## LACKS "SUBSTANTIAL COMPLIANCE" WITH ICDP: **HIGH-RISE HEIGHT**

Proposed Koll Center Residences Condo Towers

# PROPOSED CONDO TOWERS MOVE PARK TO FAR CORNER

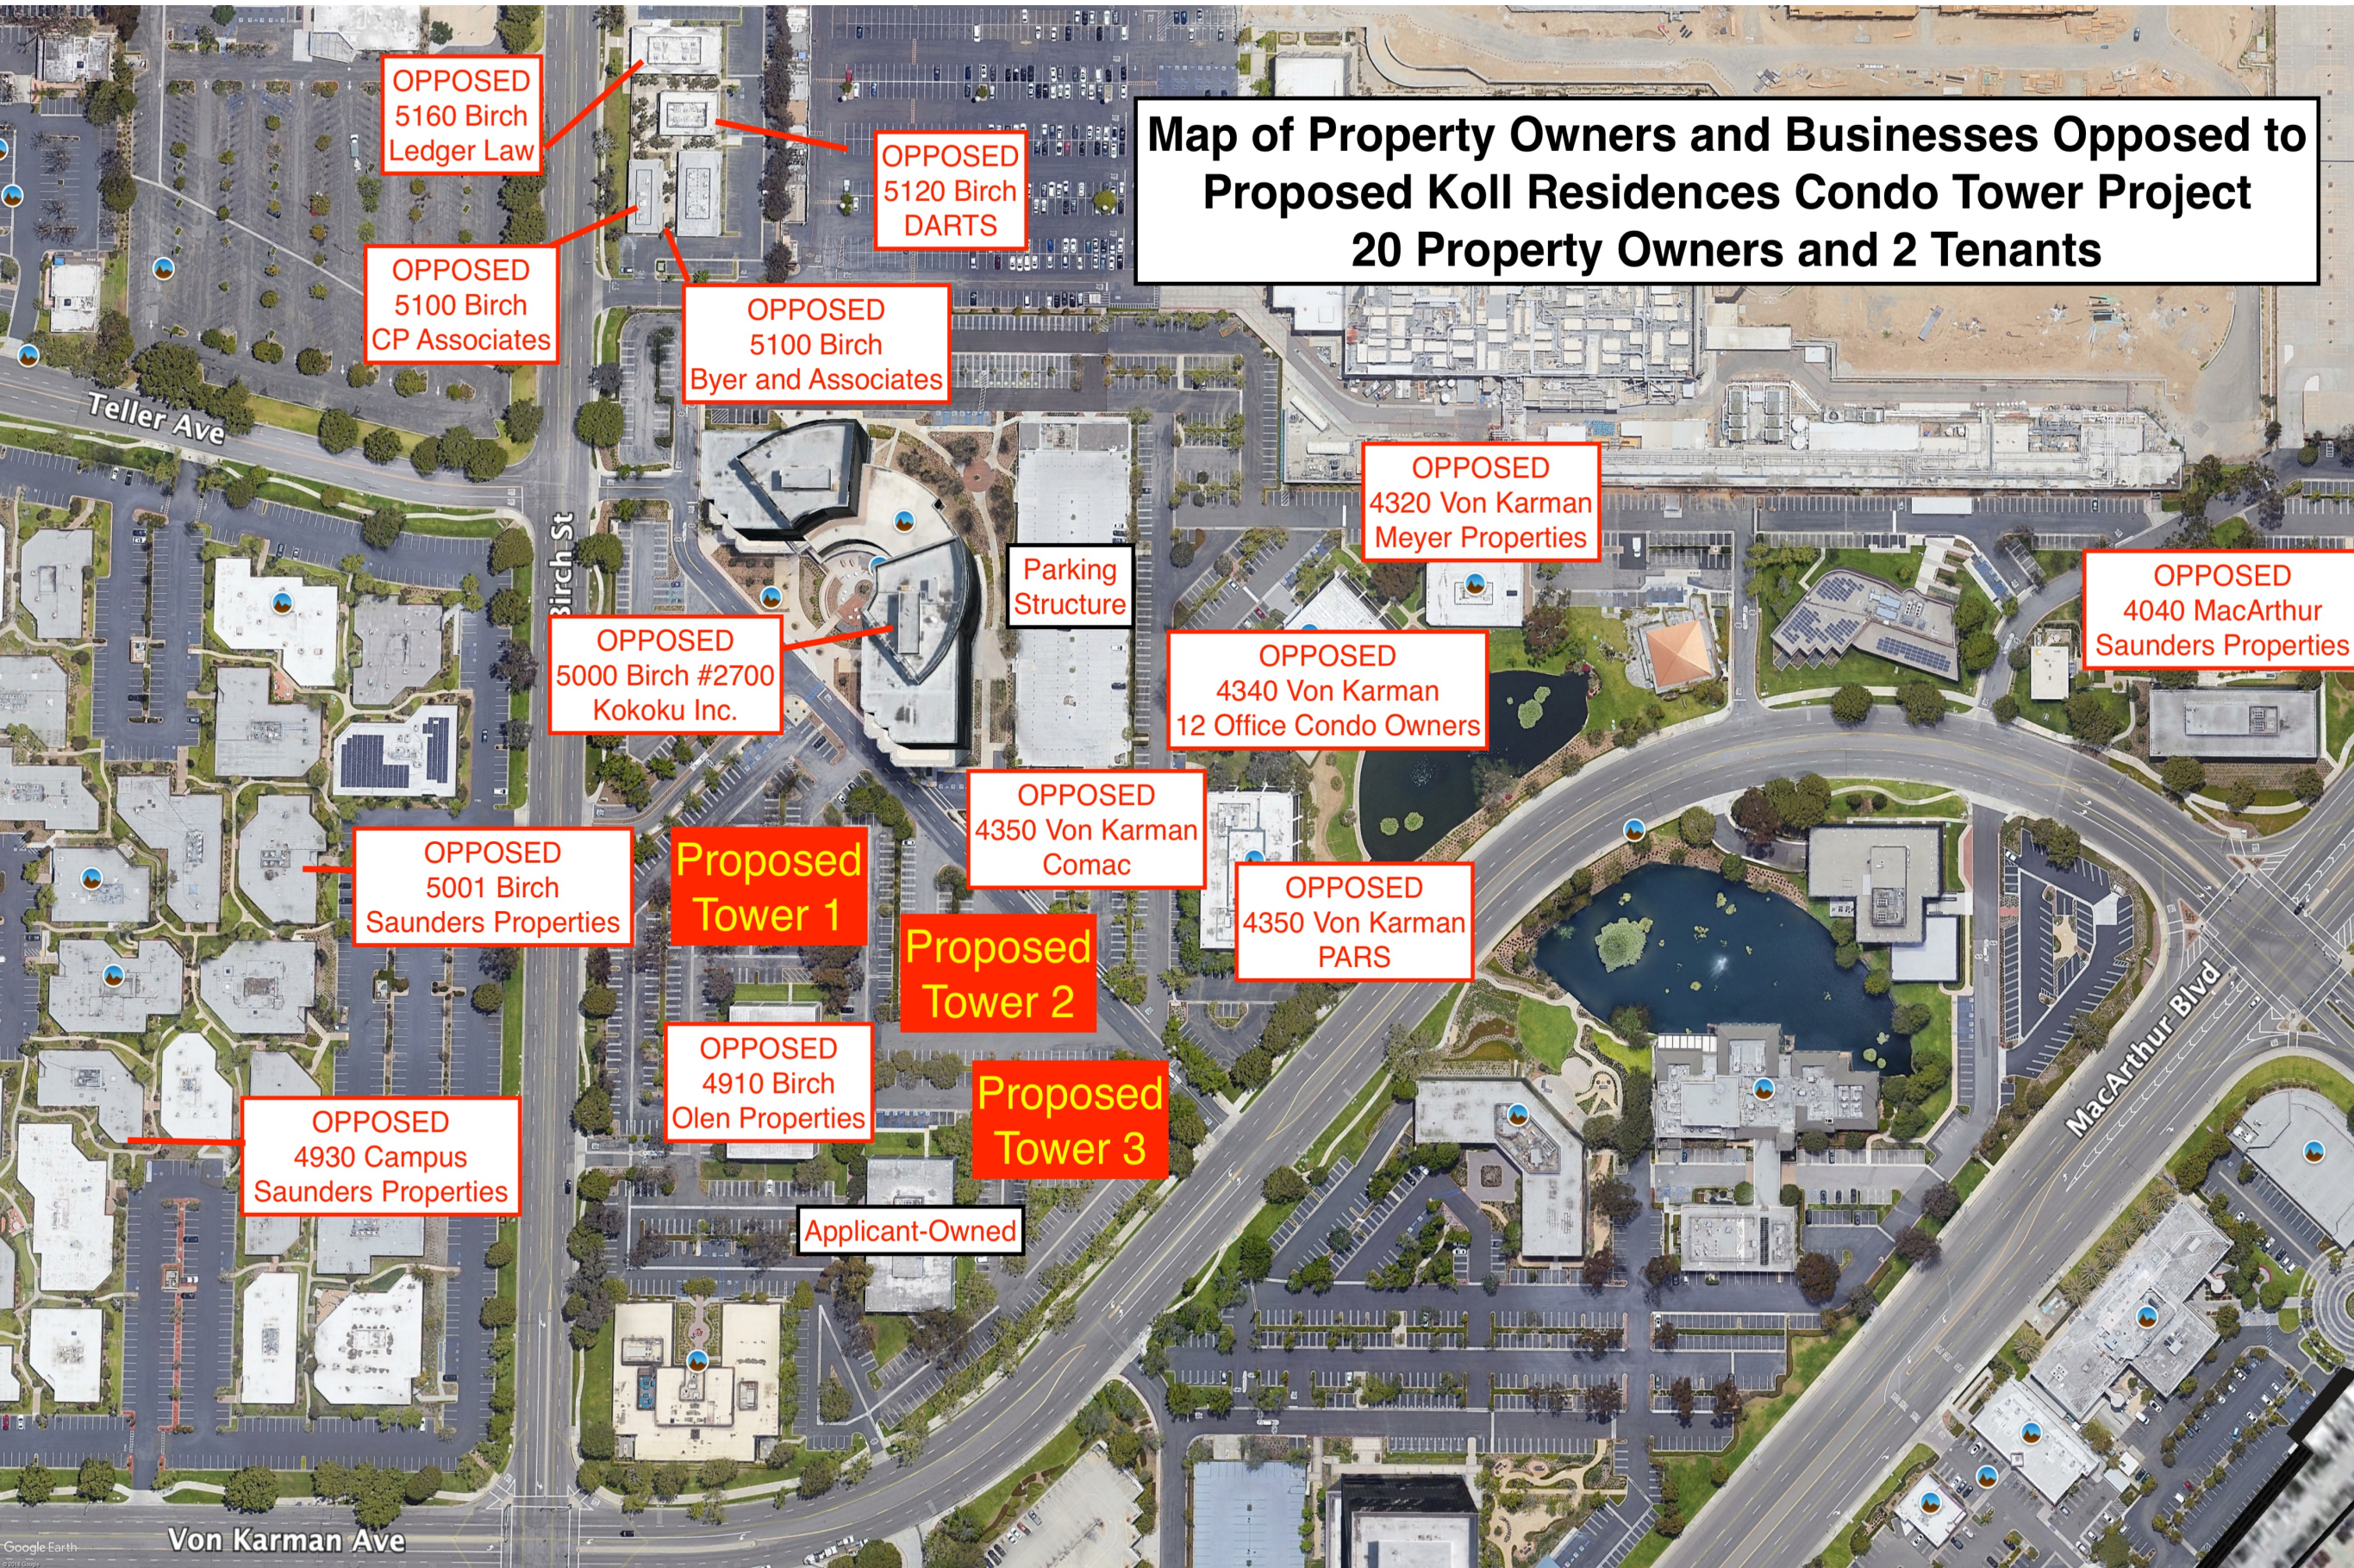
## LACKS "SUBSTANTIAL COMPLIANCE" WITH ICDP: **NO CENTRAL PARK**

- "The General Plan calls for residential villages to be **centered on neighborhood parks** to provide structure and a sense of community and identity." (2010 ICDP)
- "Koll - The Plan provides for the creation of a **central neighborhood park** of approximately one acre..." (2010 ICDP)
- "Allow development of mixed-use residential villages, each containing a minimum of 10 acres and **centered on a neighborhood park** and other amenities." (GP LU 6.15.6)
